#### Addendum No. 002

January 14, 2022

ODOT - Eaton Outpost DOT-200023

Prepared For: Ohio Department of Transportation / Ohio Facilities Construction Commission

TYPICAL FRAMING DETAILS

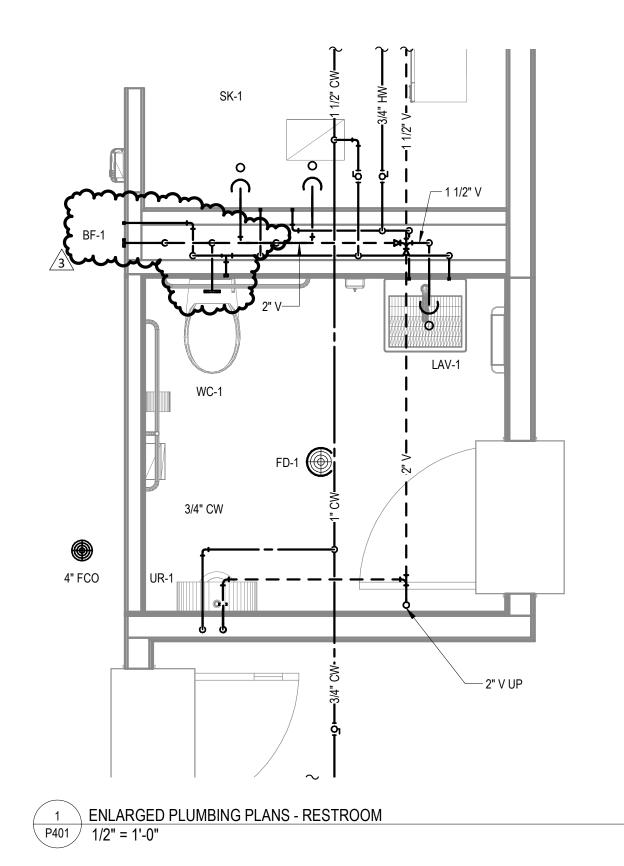
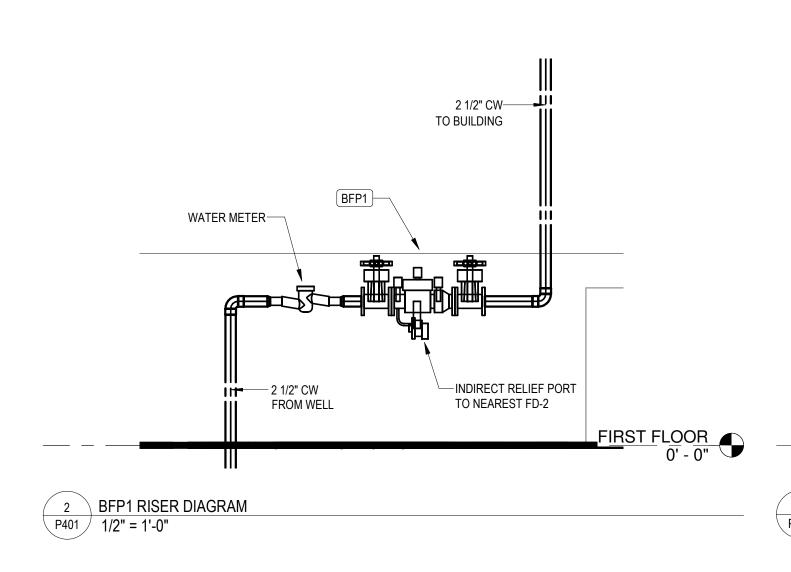
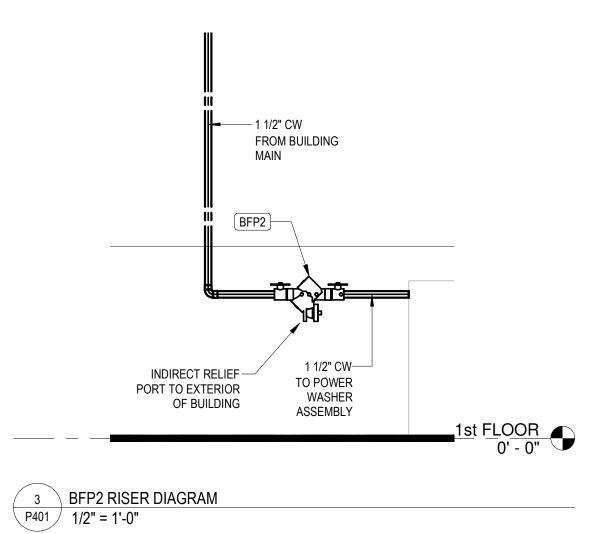
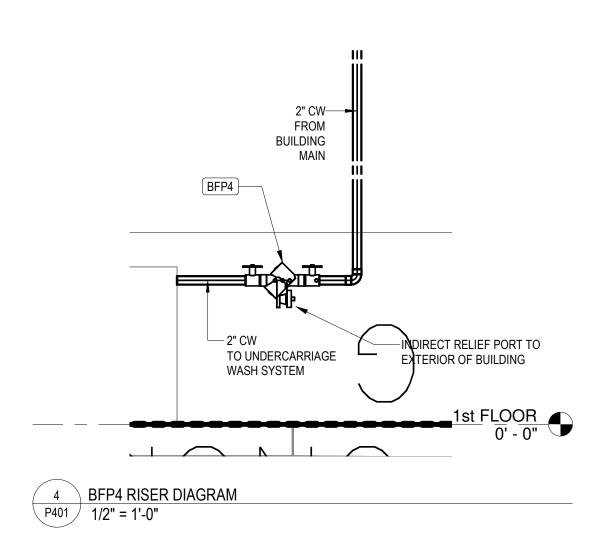
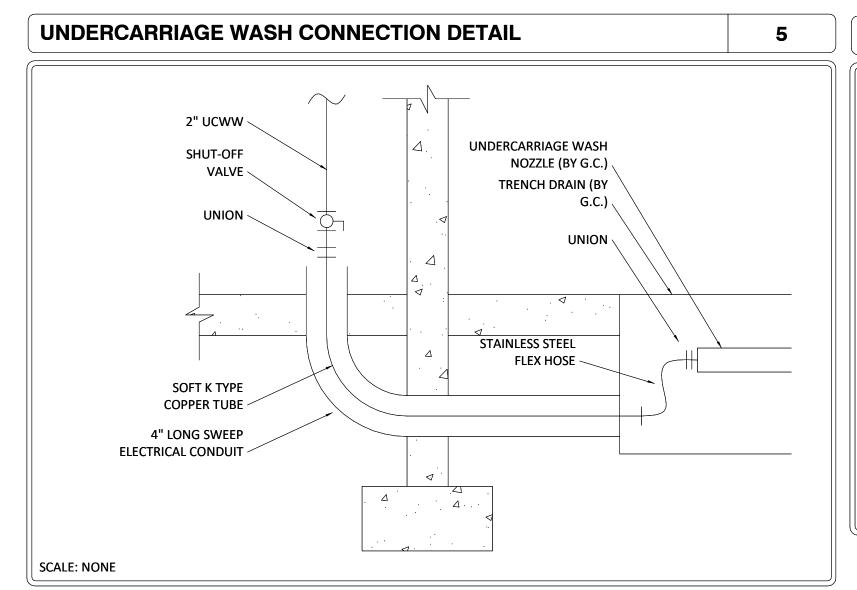
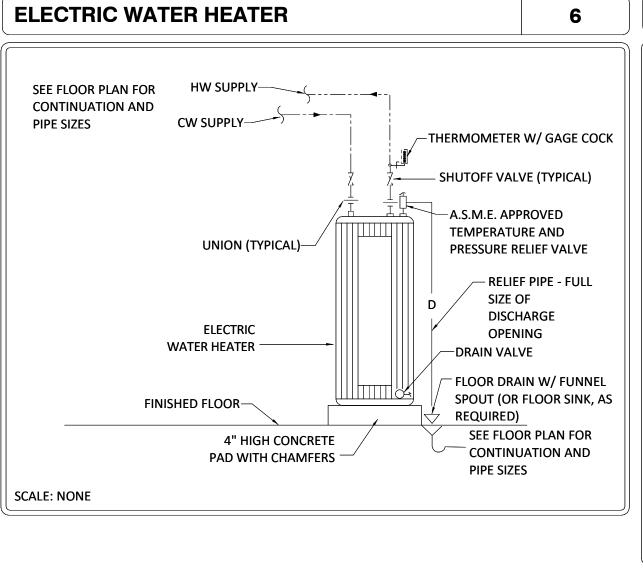
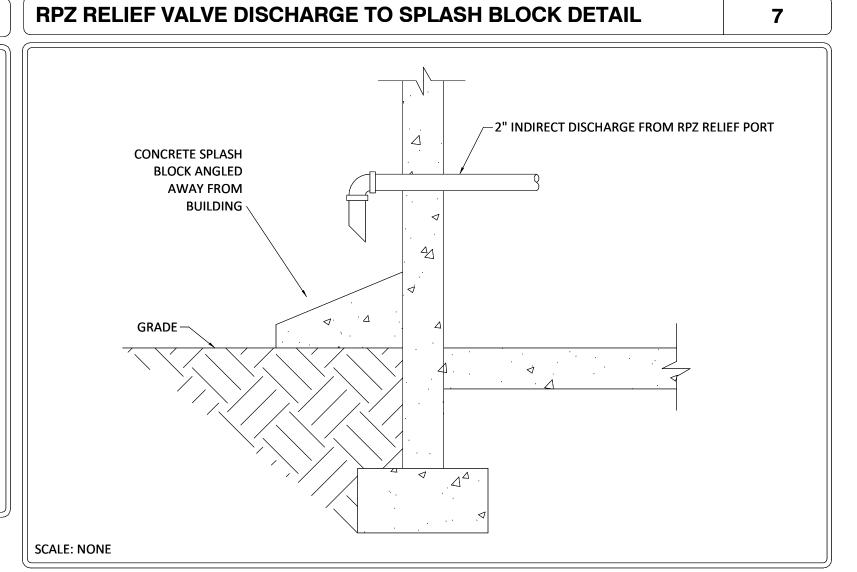
#### **Revise Sheet S-004 – TYPICAL FRAMING DETAILS (Revised Sheet Attached)**

Detail 10 – Revise Detail to include corner detail and delete note referencing arch drawings as clouded.

ENLARGED PLUMBING PLANS

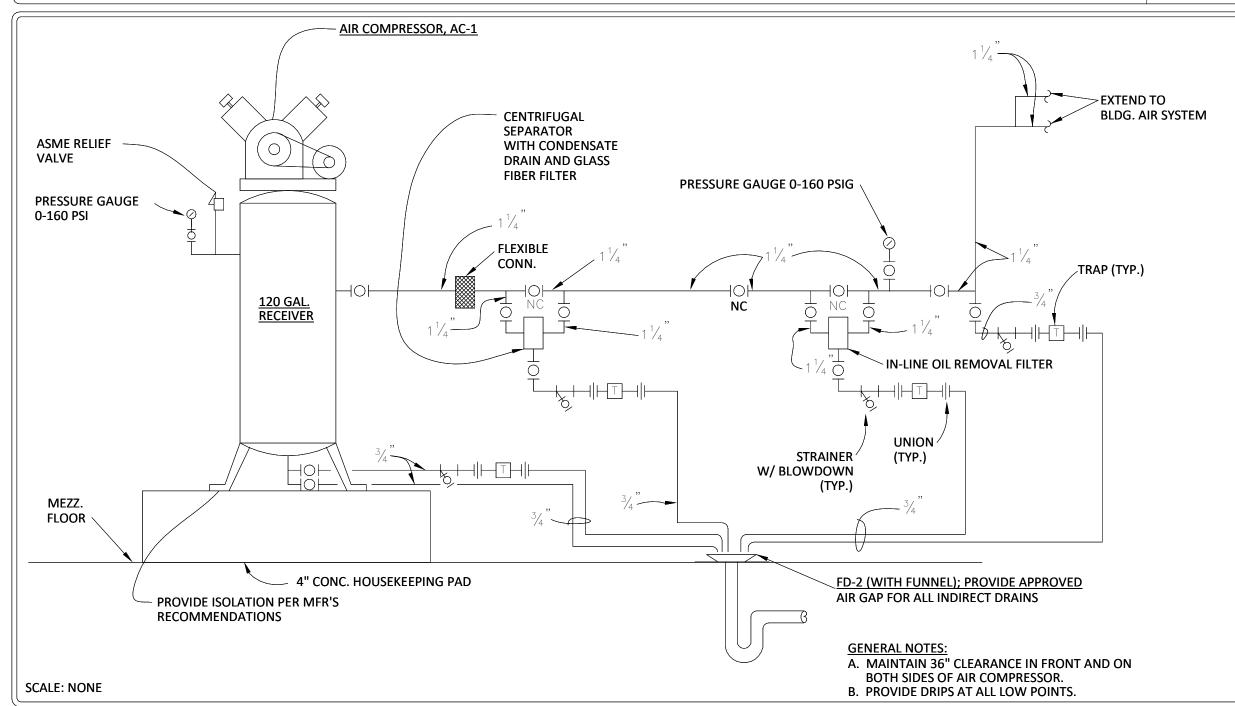
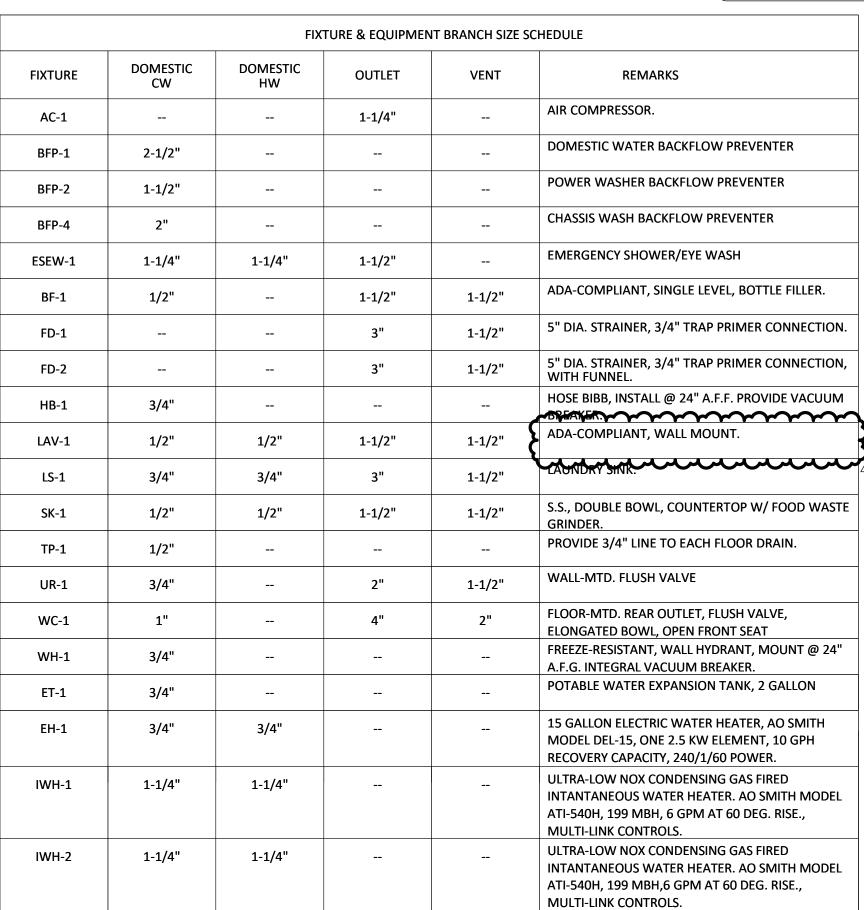
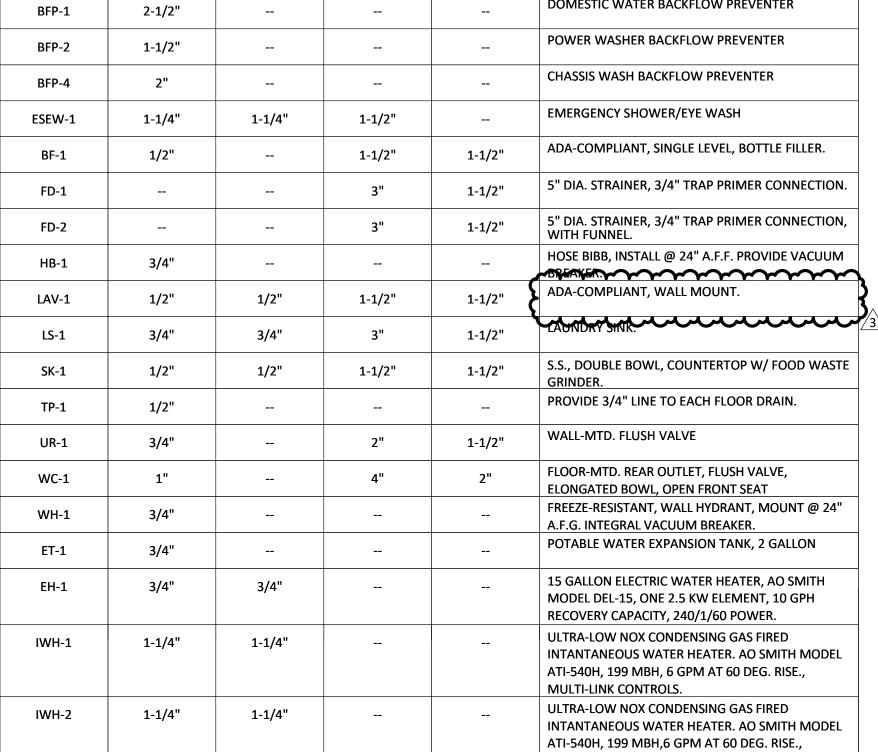
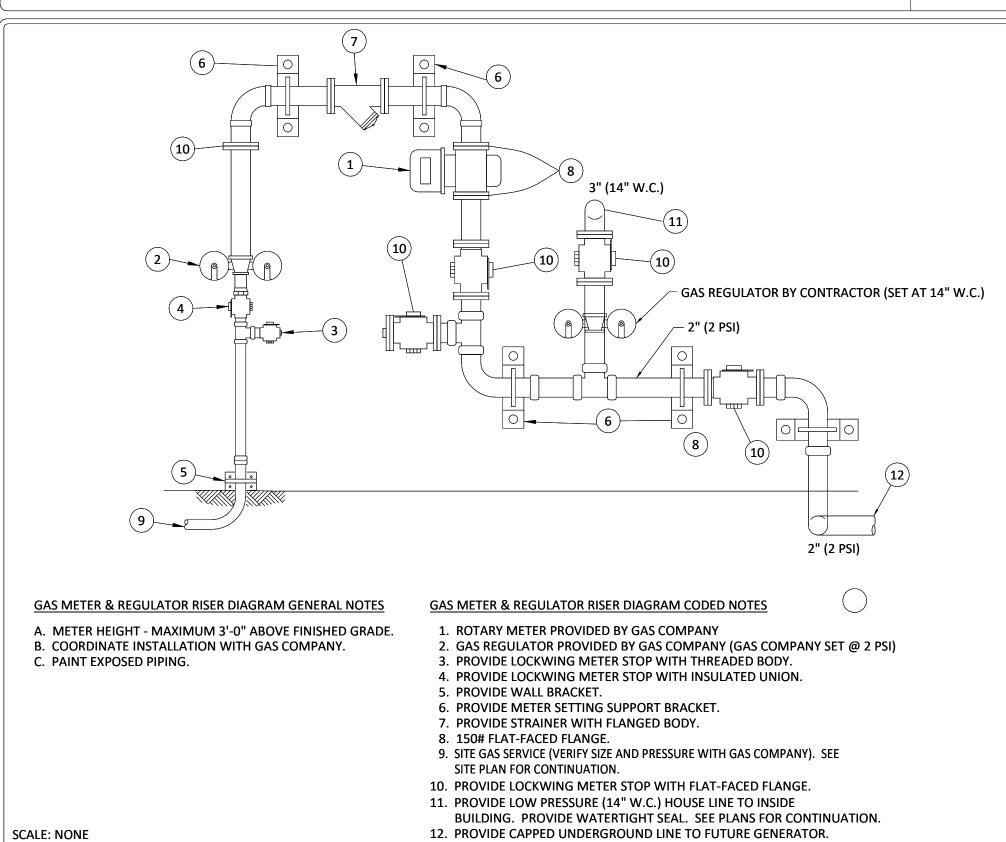
#### Revise Sheet P401 – ENLARGED PLUMBING PLANS (Revised Sheet Attached)

Revise Detail 1 as clouded to accommodate back outlet WC-1 and to show BF-1 and associated piping.

- A. BF-1 has been added to revised Sheets P401 and P901 attached herein.
- **Q5:** "In reviewing the plumbing drawings I cannot locate BFP-3 or the brine system that it is to serve. Is this backflow preventer still required? If so, where is it to be located?"

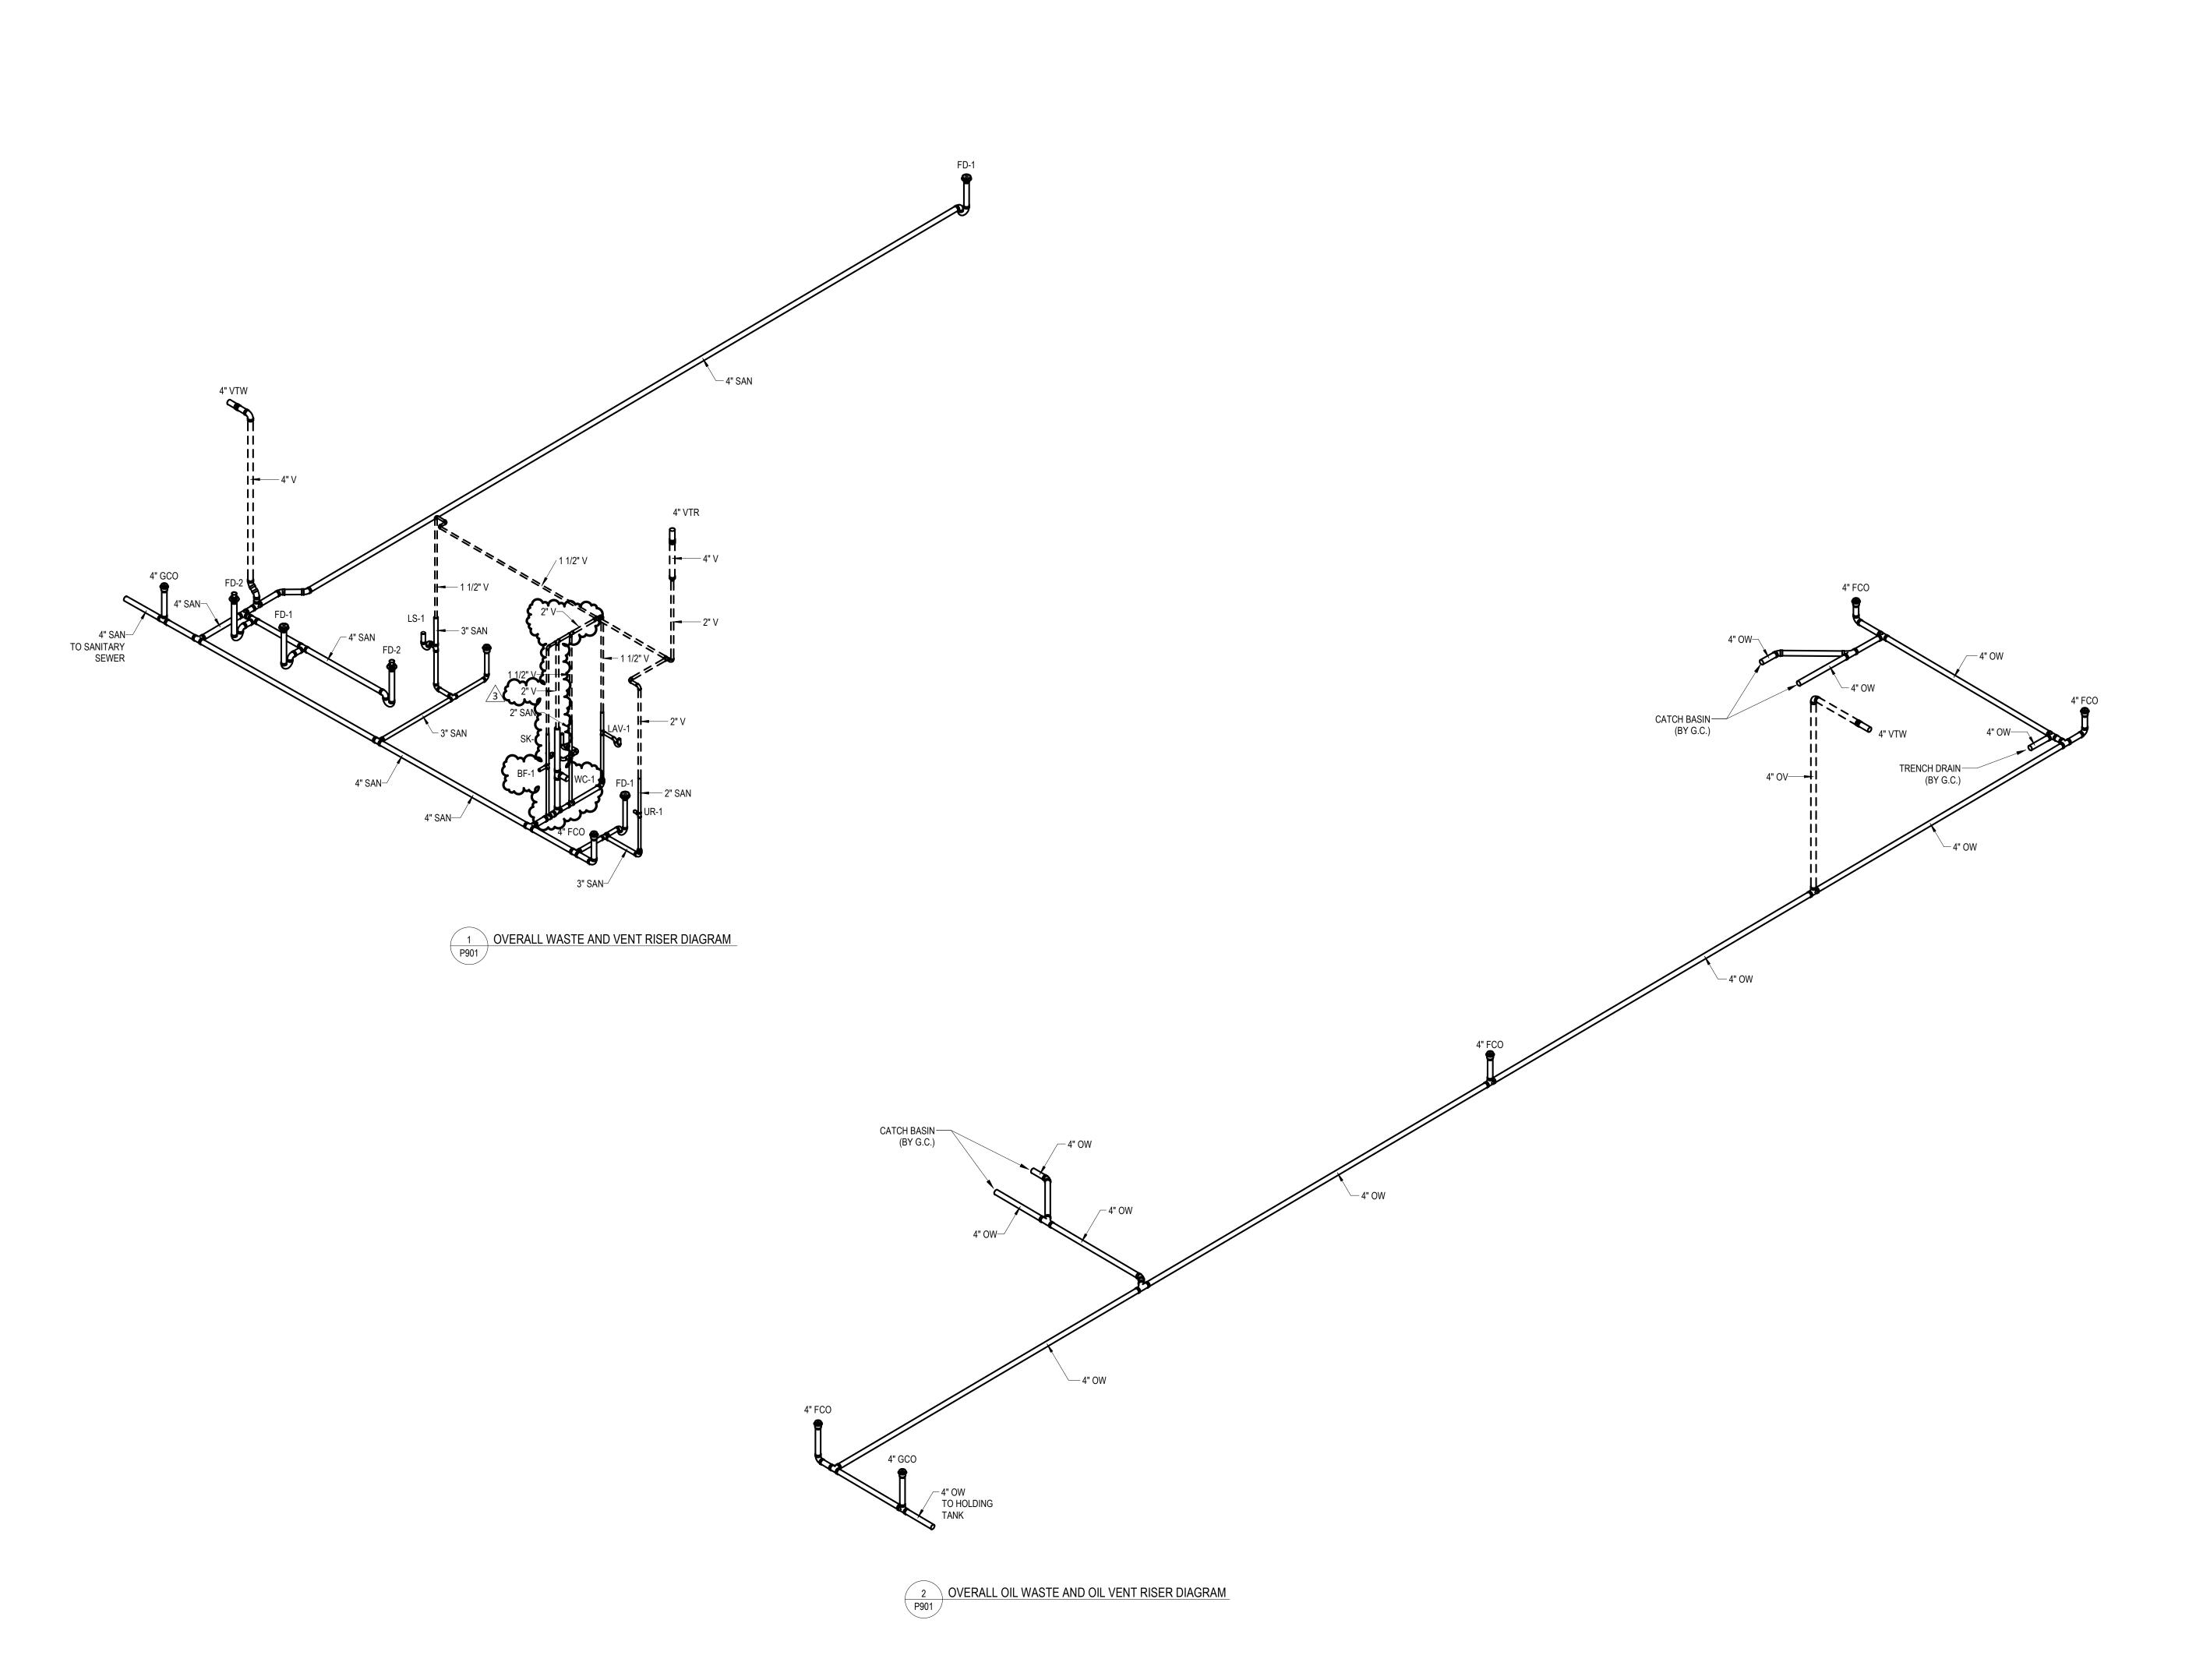
#### Revise Sheet P601 – PLUMBING SCHEDULE & DETAILS (Revised Sheet Attached)

Revise schedule remarks for LAV-1 to "ADA COMPLIANT, WALL MOUNT" as clouded.

Remove BFP-3 from fixture schedule.

- A. Brine system backflow is not required. BF-3 has been removed from the plumbing schedule in revised sheet P601 included herein.
